SERVICE BULLETIN

APPLICABILITY: 2015-16MY and Early 2017MY Legacy and Outback

NUMBER: 07-114-16

SUBJECT: Power Seat Memory Feature Operating Concerns

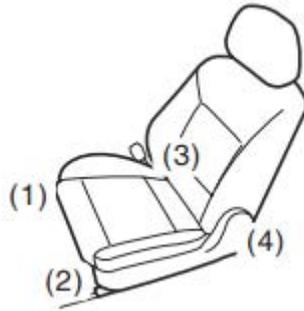
IMPORTANT: The part number and location of the new seat memory control module are unchanged. For this reason, the color of the part number label affixed to the module must be confirmed to differentiate between the old and new parts as shown in the illustration below. The old module label is Blue (inset) while the new version is Brown.

- When replacing the module, torque the 2 retaining nuts to 5.9 Nm (4.4 ft. lbs.).
- When reinstalling the seat assembly, the 4 retaining bolts must be hand-tightened first then final torqued to 53 Nm (39.1 ft. lbs.) using the sequence shown in the illustration below.
